PROJECT ID NO. SWQ0000005

**MONTEITH PARK AND VIEW PARK
GREEN ALLEY STORMWATER IMPROVEMENTS**

NOTICE INVITING BIDS

SECTION E2-E2

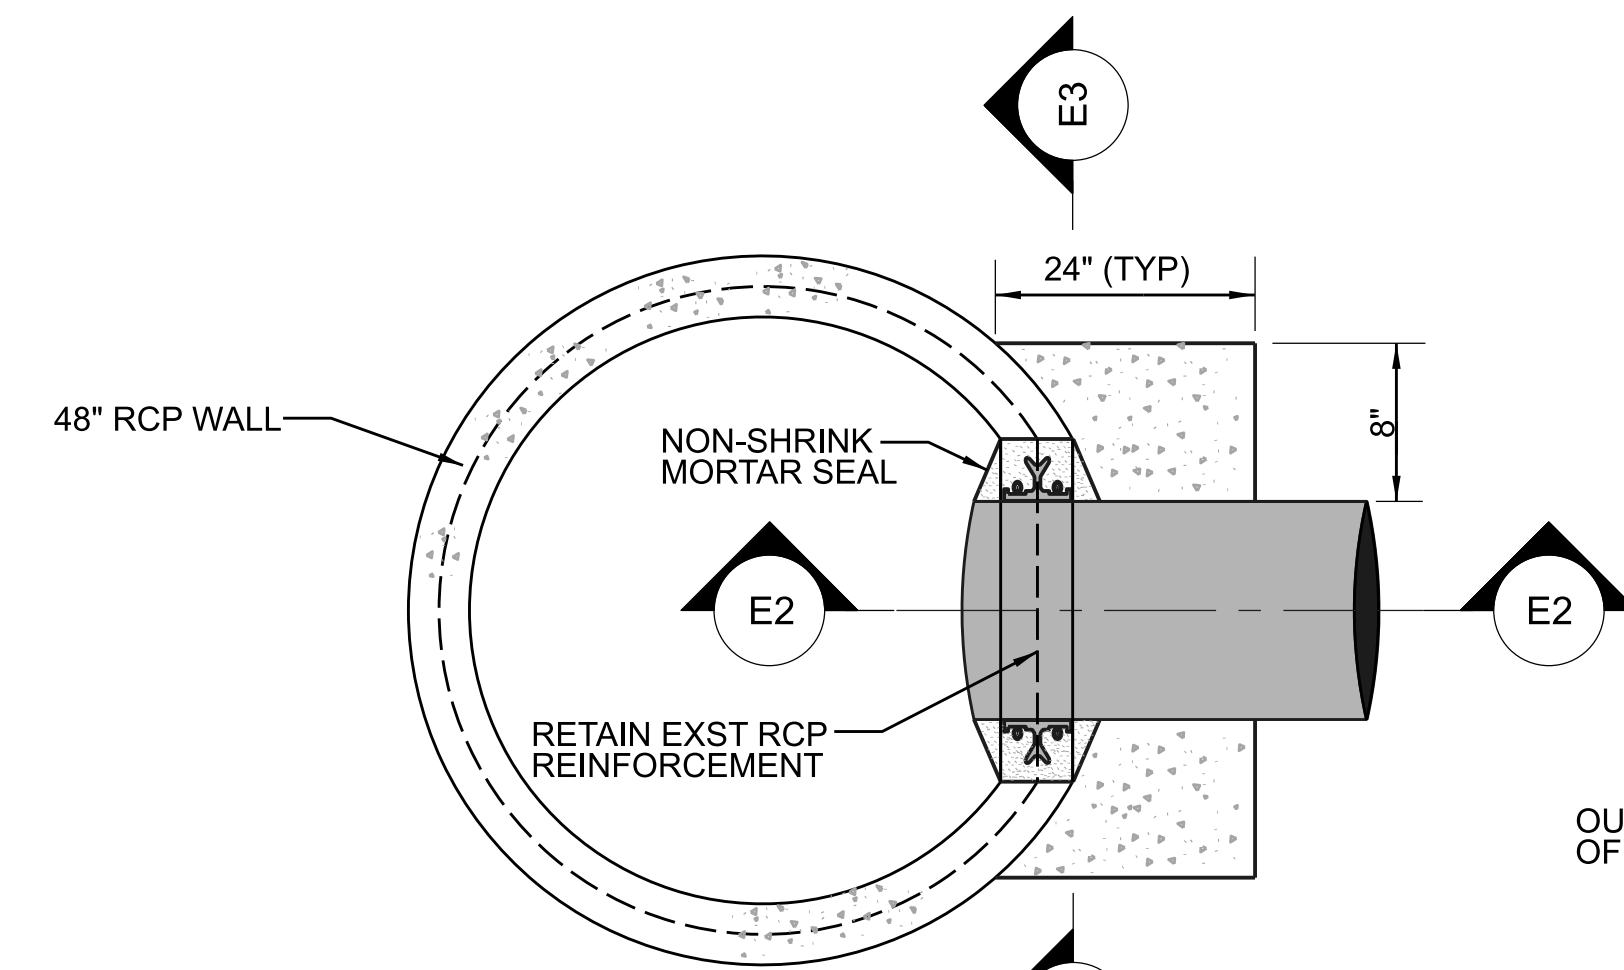
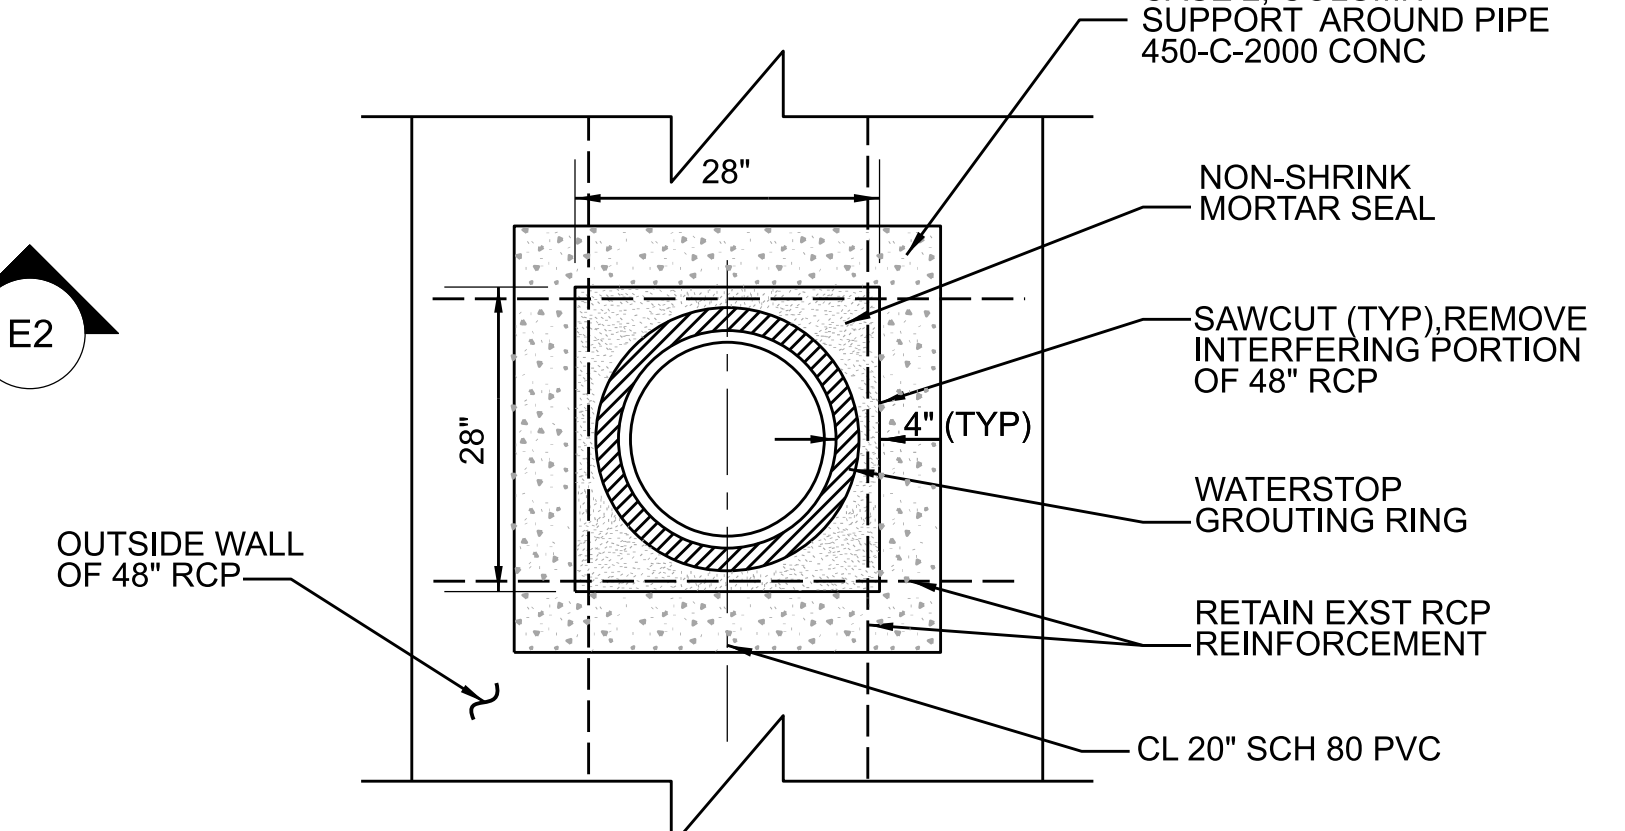
Q18. *The bottom dimension for the Case 1 drywell shown on drawing DR-10 is 78'. The dimension for the 16" Slotted Screen PVC is 64' plus 2' on the top and bottom. Please advise if the 78' dimension should be 68'?*

A18. The bottom dimension of 78 feet for the Case 1 drywell shown on Sheet DR-10 is revised to 68 feet. Refer to the revised Plan sheets included with this Addendum No. 2.
